UNITED STATES PATENT AND TRADEMARK OFFICE

APPLICATION NO.	FILING DATE	FIRST NAMED INVENTOR	ATTORNEY DOCKET NO.	CONFIRMATION NO.
09/681,674	05/18/2001	Yoshifumi Natsuyama	JP920000096US1	3666
7590 12/28/2005 ANNE V. DOUGHERTY, ESQ. 3173 CEDAR ROAD YORKTOWN HEIGHTS, NY 10598			EXAMINER RUDE, TIMOTHY L	
			ART UNIT 2883	PAPER NUMBER

Office Action Summary

DETAILED ACTION

Figure 11

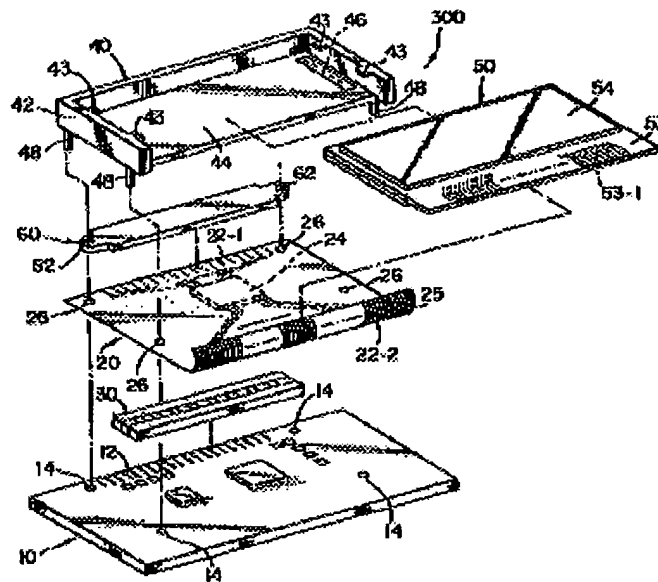
As to claim 4, Muramatsu discloses in his third embodiment, [Figures 11 and 12, col. 10 line 66 through col. 13, line 6] a liquid crystal display panel comprising: a pair of glass substrates facing each other, each having electrodes for applying voltage to a liquid crystal material on a facing surface (typical); a circuit board, 10, for supplying said voltage; and a liquid crystal driver tape carrier package, [20, col. 11, lines 7-9 and col. 7, lines 1-3] for connecting said electrodes of said glass substrates to said circuit board and mounting at least one liquid crystal driver chip [col. 11, lines 7-9 and col. 7, lines 4-13], wherein said liquid crystal driver tape carrier package and said circuit board each have more than two anchor holes, [four of 26 and 14 respectively], and anchor pins, 48, are inserted into said anchor holes, whereby said liquid crystal tape carrier package is fixed to said circuit board [col. 11, lines 45-48], wherein said anchor holes are located in a path region of substantial propagation of stress resulting from a difference in coefficients of linear expansion between the circuit board and the glass substrates of

the liquid crystal display panel, and more than two anchor pins, 48, are inserted, one pin into each of said more than two anchor holes.

Muramatsu also discloses the liquid crystal display device wherein a pair of said anchor holes, 26, is located with said liquid crystal driver chip, 24, between [diagonally per Figure 11].
